Department of Transportation

MEMORANDUM

SUBJECT: BZA Case No. 21010 – 1271 5th Street NE

Figure 1 | Nearby Off-Street Parking Facilities

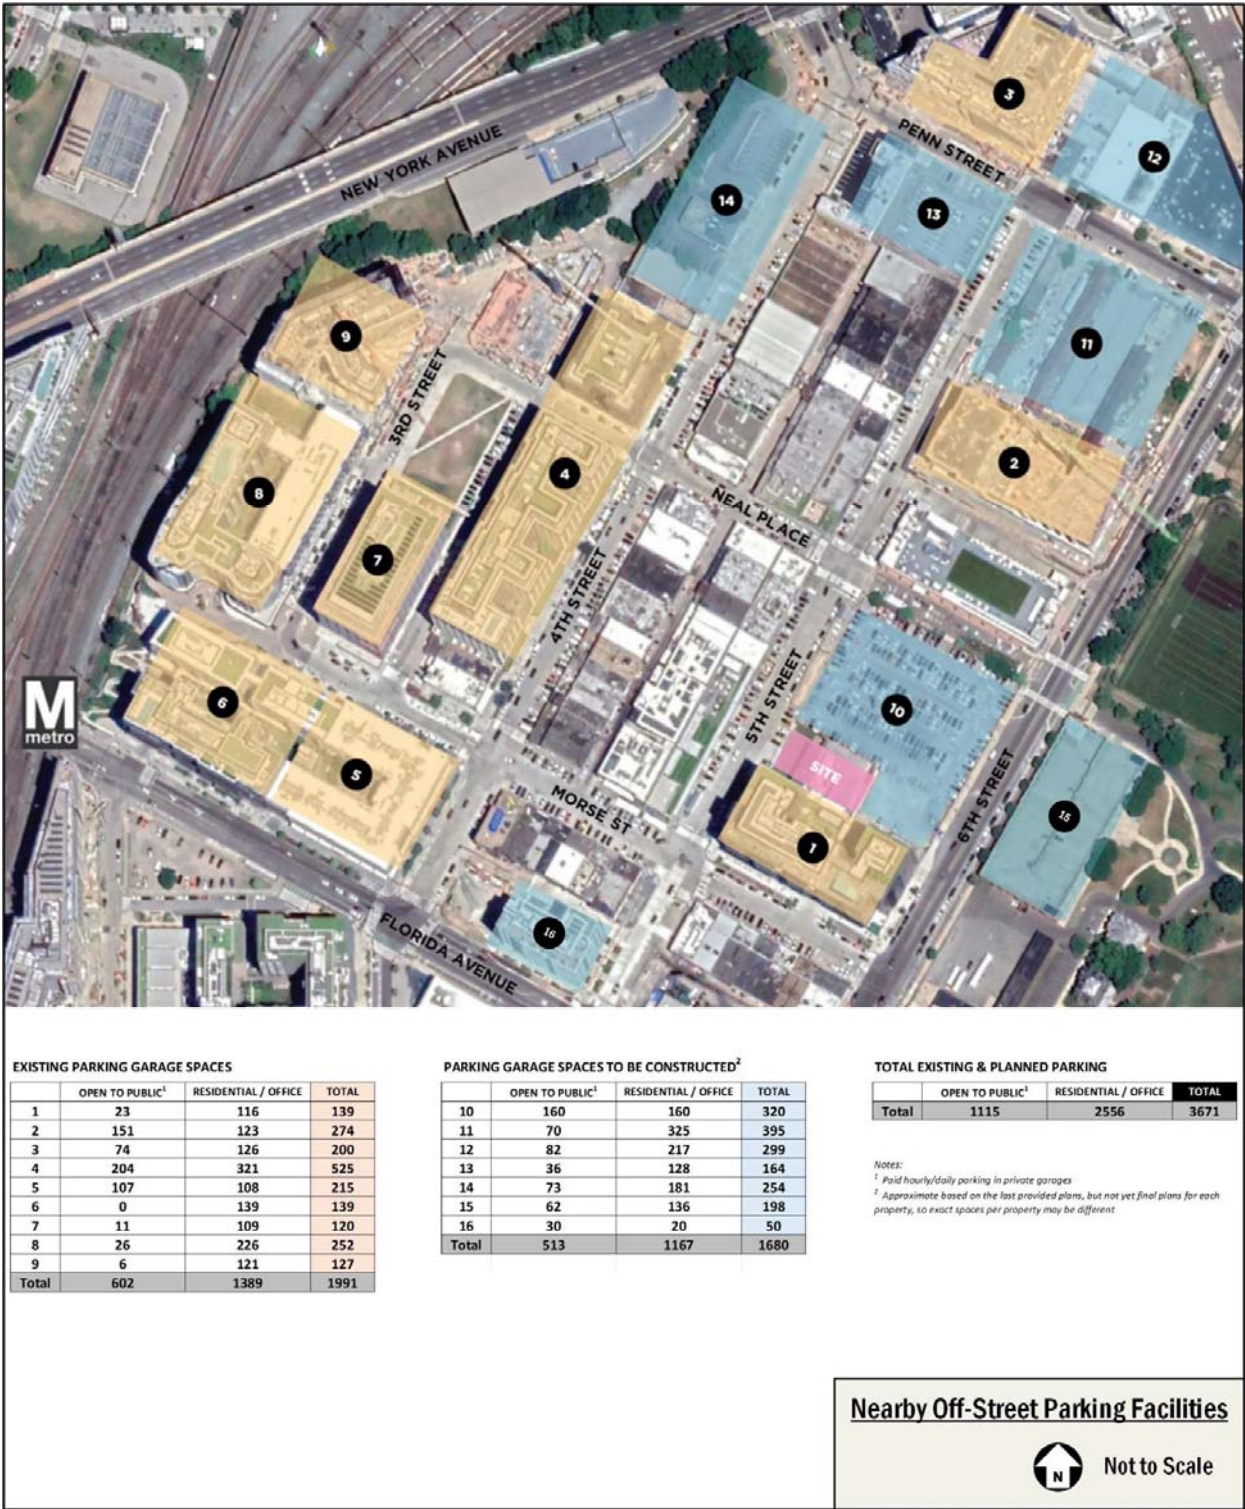
The Applicant is required by Zoning to provide either 26 or 20 off-street parking spaces for Scenarios A or B, respectively. Per the Applicant's Architectural Plans, the Applicant is not providing any off-street parking spaces and is seeking relief from all off-street parking spaces required by Zoning. During project scoping, DDOT requested that the Applicant include a graphic that shows existing and proposed parking garages and their parking supplies within walking distance of the site to illustrate the availability of off-street parking open for use by visitors and patrons of the proposed project. As shown in Figure 1, more than 600 paid hourly or daily parking spaces already exist in the Union Market neighborhood within walking distance of the site. More than 20 spaces are located in the neighboring site abutting to the south and approximately 160 spaces expected as part of the neighboring development abutting to the north. This existing and planned supply of off-street parking can support the expected parking demand of the proposed project and the requested parking relief.

- Due to the site's proximity to the NoMa-Gallaudet U Metrorail station, two (2) high-frequency Metrobus routes, carsharing facilities, nearby publicly available parking garages and Capital Bikeshare stations, DDOT has no objection to the Applicant's request for relief from off-street parking spaces;
